**NPDES PERMIT FACT SHEET
ADDENDUM**

Application No. PA0027197
APS ID 276152
Authorization ID 1032943

RE: Comments of Capital Region Water on Draft NPDES Permit – Sewage
Harrisburg Advanced Wastewater Treatment Facility
Application No. PA0027197; Authorization ID No. 1032943
Harrisburg City, Dauphin County

Figure 1 – Location of CRW's AWTF and Three Mile Island

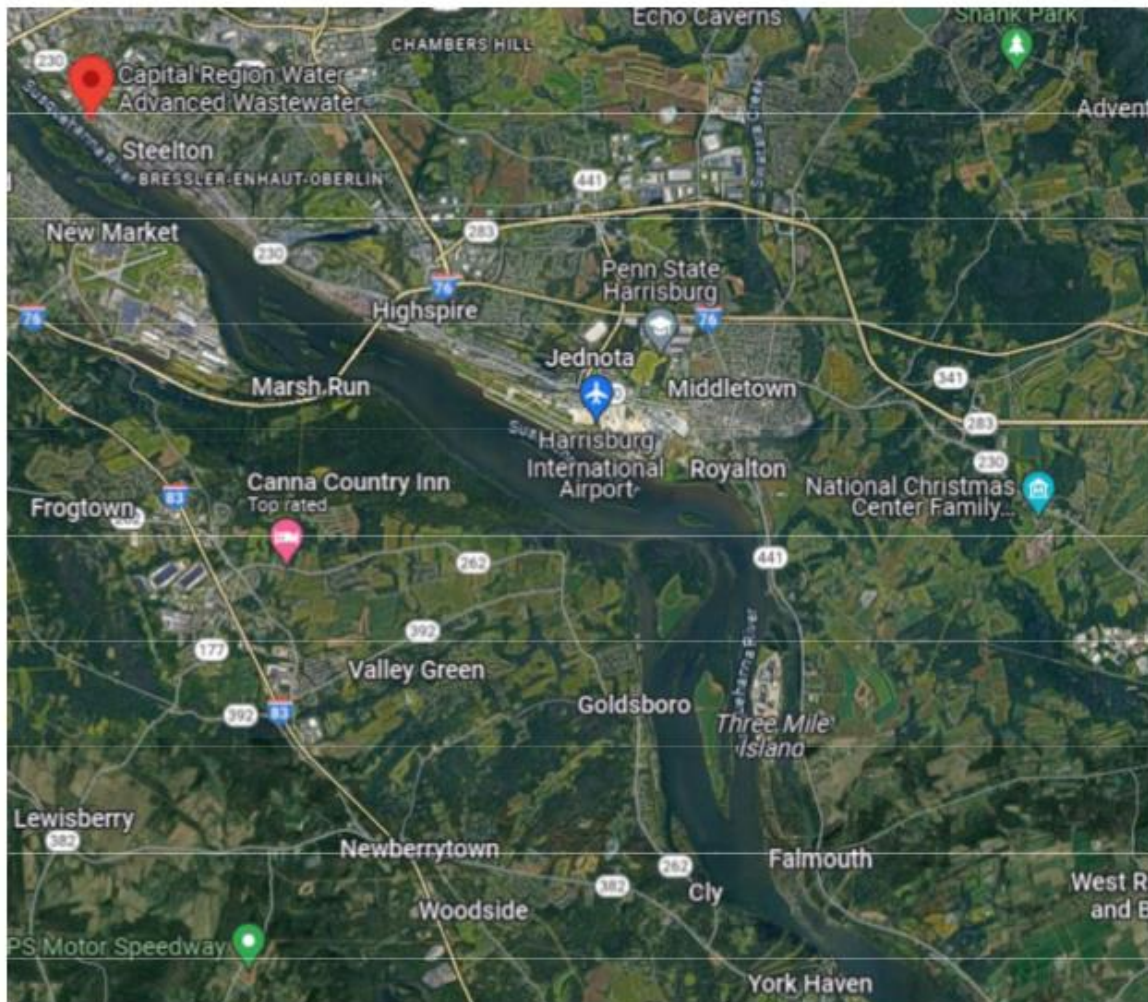
Since the distance to complete lateral mixing needs to be close to 4,000 miles to match the partial mix factors cited in DEP's Fact Sheet, DEP's assumptions are clearly unreasonable and cannot be used to assess the lateral mixing extent in the 15-minute and 12-hour durations associated with the acute and chronic effluent limits. While there is uncertainty in the extent of lateral mixing in the Susquehanna River downstream of the AWTF outfall, complete lateral mixing is likely to occur by Three Mile Island due to the large bend in the river and the downstream hydroelectric plant (**Figure 1**), far closer than 4,000 miles.

- The islands in the river limit the width and flow available for mixing, especially for the 15-minute mixing time associated with the acute partial mix factor. The use of the full river width and flow is overly conservative in this case.

Based on the comments received from the permittee (Capital Region Water), the Department has determined to provide the permittee an opportunity to conduct a site-specific study that would include a site-specific dilution study, evaluation of the best available technologies and selection of technology. The permittee requested 22 months as the interim period to conduct the study. The Department has determined that this request is reasonable and therefore, the new WQBELs will be in effect 22 months after issuance of the permit IF the Department's Water Quality Model (i.e., TRC_CALC spreadsheet) using their study results still shows that new WQBELs listed in the November 13, 2023 draft permit are still needed. Therefore, the following compliance schedule will be provided in Part C of the permit.
